DCC Comment on the Southern Link Inland Port

[FTAA-2604-1207]

Figure 1: Noise contour map of nighttime operation (reproduced from the Noise Assessment), annotated to show vacant land that will receive night time noise levels higher than the permitted noise standards

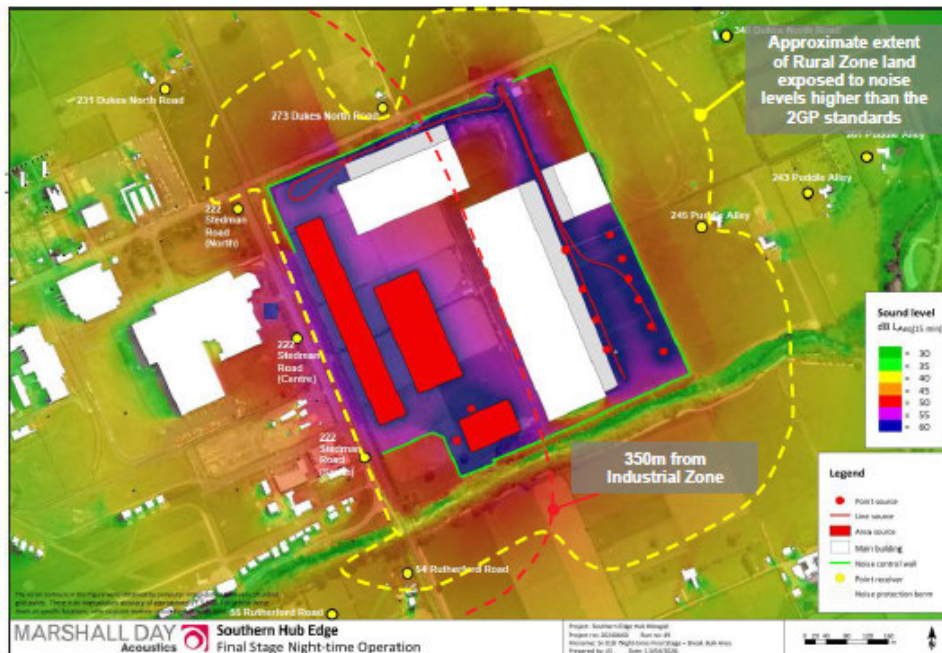
Figure 1 overleaf reproduces the nighttime noise contour map for Stage 3 provided in the Noise Assessment. The yellow dashed line shows the approximate extent of the land around the Site that is predicted to receive night time noise levels over 40 dB L_{Aeq} for land in the Rural and Rural-Residential Zone that is more than 350m from the Industrial Zone, and 45 dB L_{Aeq} where the receivers are within 350m of the Industrial Zone.

We note that the 2GP nighttime noise standards of 40 dB L_{Aeq} and 70 dB L_{AFmax} are designed to provide receivers in Rural and Rural Residential Zones (that are more than 350m from the Industrial Zone) with a greater level of night time acoustic amenity. Proposed Condition 68 does not recognise or provide for this.

As set out above, the Noise Assessment does not assess the effect that this might have on neighbouring vacant land and fails to assess the impact it may have on activities on neighbouring land that are anticipated by and provided for in the 2GP. The AEE fails to recognise it altogether.
